## SUBMITTAL SUMMARY REPORT 33241

**PLAN NAME:** WEST MINI FARMS

**OCE: Plan Review (DR) v.1**

**BOUNDARY & TOPOGRAPHIC SURVEY**

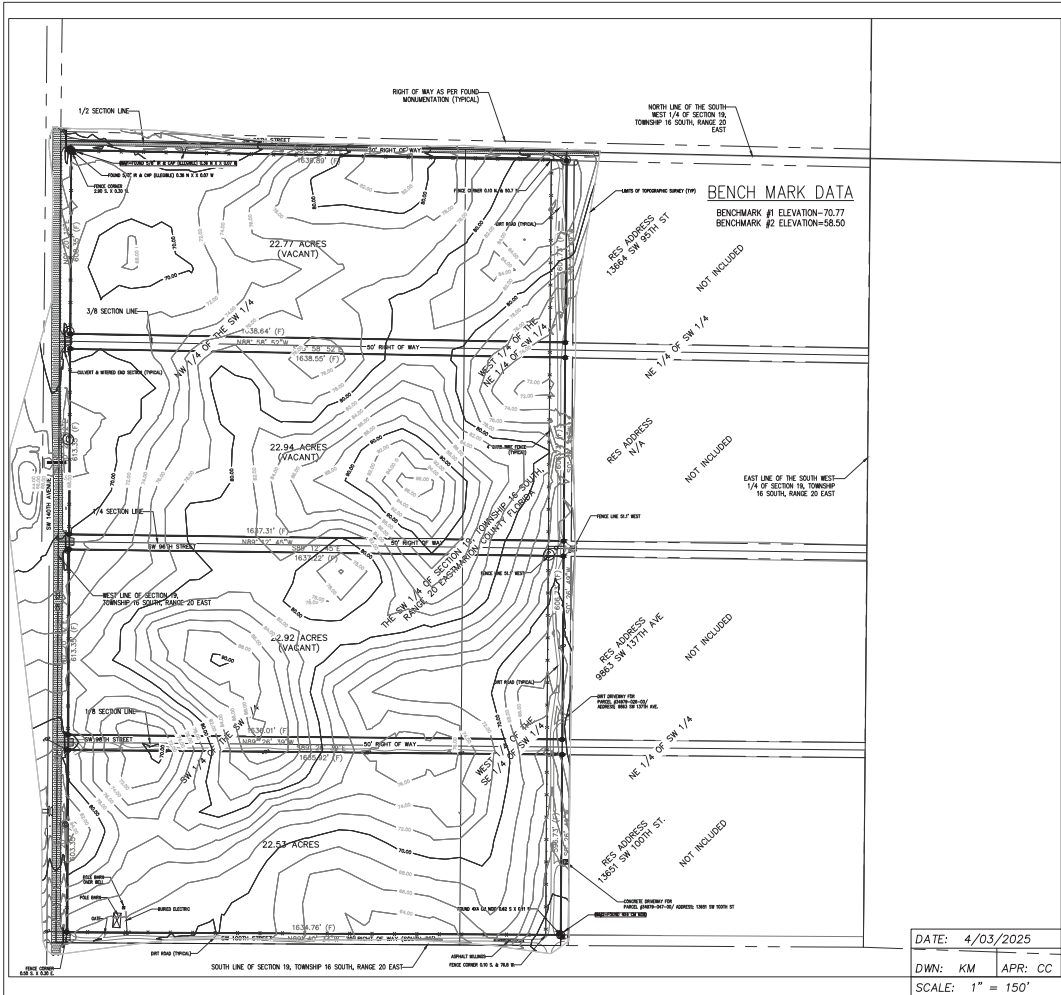
<i>Comments</i>	<p>YES 6.2.1.A - The name, street address, signature, date, license number, and seal of the responsible professional shall be shown on each plan sheet.</p> <p>NO 6.2.1.F - Provide north arrow and graphic drawing and written scale</p> <p>Please add graphic scale to boundary &amp; topographic survey.</p> <p>YES 6.4.7.A(1) - Provide a minimum of two bench marks per site with a statement or table detailing vertical datum</p> <p>NO 6.4.7.B(1) - Provide a minimum of two intervisible horizontal control points per site Please provide.</p> <p>NO 6.4.7.B(2) - Horizontal control points shall be monumented and referenced to the Florida State Plane Coordinate System Please provide.</p> <p>NO 6.4.7.B(H) - Control points shall be referenced Please provide.</p> <p>YES 6.4.7.D - The location of the existing one percent (100-year) flood plain as shown on FEMA FIRM, with zone, elevation, and vertical datum noted</p> <p>N/A 6.4.7.E - Line and curve tables must be shown on the sheet to which they apply</p> <p>YES 6.4.7.F - All abbreviations used shall be clearly defined in the legend</p> <p>N/A Additional Survey comments</p>
